Temporary Shop and Services and Eating Place for a Period of 5 Years in “Village Type Development” Zone, Lot 390 RP (Part) in D.D. 106, Kam Sheung Road, Kam Tin, Yuen Long

(S.16 Planning Application No. A/YL-KTS/990)

Responses-to-Comments

Drainage Appraisal

Annex A – Photographic records showing the presence and existing condition of the discharge path

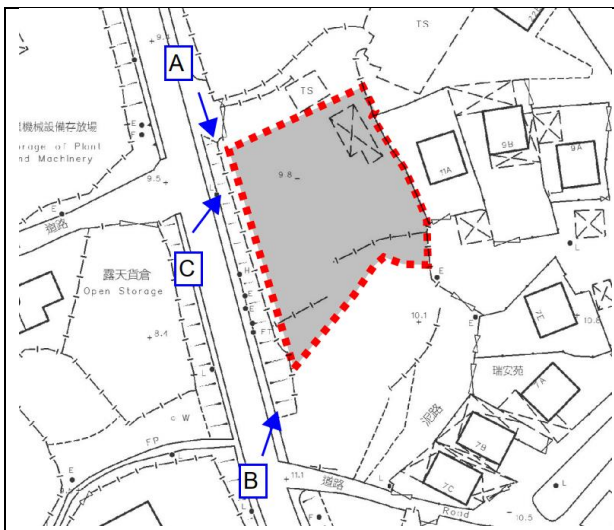
is a local village drains, DO/YL should be consulted.	
v)	Further to (iv) above, since there is no record of the said discharge path, please provide site photos to demonstrate its presence and existing condition.	Noted. Please refer to the photo in Annex A .
vi)	Please confirm if any walls or hoarding are/to be erected or laid along the site boundary. If affirmative, adequate opening should be provided to intercept the existing overland flow passing through the site and please provide its details for comments.	Noted. Fence with gap would be provided. Please refer to the below photo for the existing fencing. 
vii)	Standard details should be provided to indicate the sectional details of the proposed u-channel and the catchpit/sand trap.	Please refer to standard drawing in Appendix C showing u-channel and catchpit with trap for your review.
viii)	The development should neither obstruct overland flow nor adversely affect existing natural streams, village drains, ditches and the adjacent areas, etc.	Noted.
